Your ref: APP-20232970  
Our ref: 12553730

### Request for further information on resource consent application - APP-20232970

In response to your email dated 12 June 2023, additional information has been provided in this letter to address your further questions regarding the Edendale – Wyndham Wastewater Treatment Plant.

Figure 2 Policy 15A pSWLP extract from Decision No. [2023] NZEnvC 051

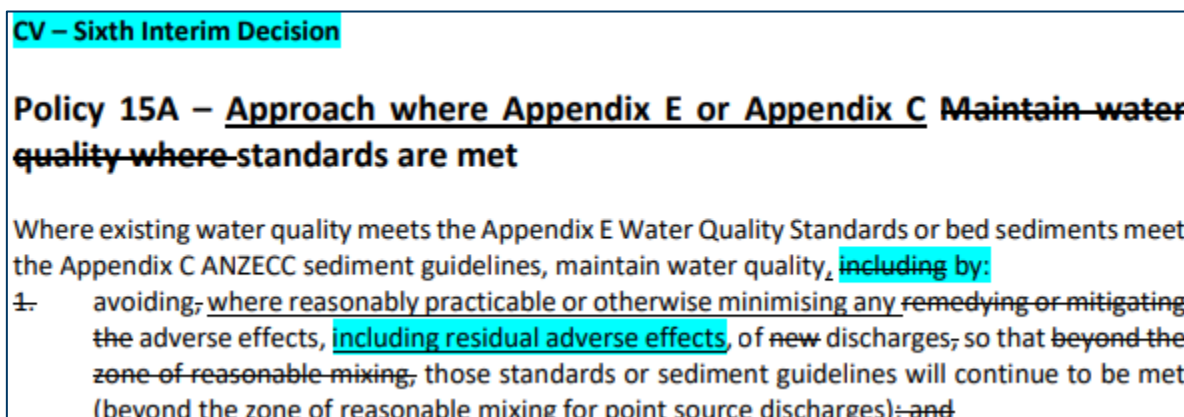
- I'm not convinced Policy 15A (pSWLP) applies, I believe its 15B due to occasional E.Coli exceedances of the discharge that has occurred as part of the current consent and as explained in your response to question 6. Furthermore, there is no certainty that the new lower thresholds for E.Coli with a small mixing zone will help in this matter.

The application was previously assessed against an earlier version of Policy 15A of the pSWLP. However, to give effect to the provisions of the sixth Interim decision (Decision No. [2023] NZEnvC 051) the following assessment should be adopted when considering the application. The intention of the five-year consent is to maintain water quality while further investigation is underway by SDC. There have been some improvements to the management regime of the WWTP in recent years and further options are currently being considered which would remove phosphorus, suspended solids and improve UV disinfection efficacy. The future operation of the wastewater scheme and compliance with the proposed consent conditions, will ensure that the water quality standards will continue to be met (beyond the zone of reasonable mixing). The application is therefore consistent with Policy 15A of the pSWLP.
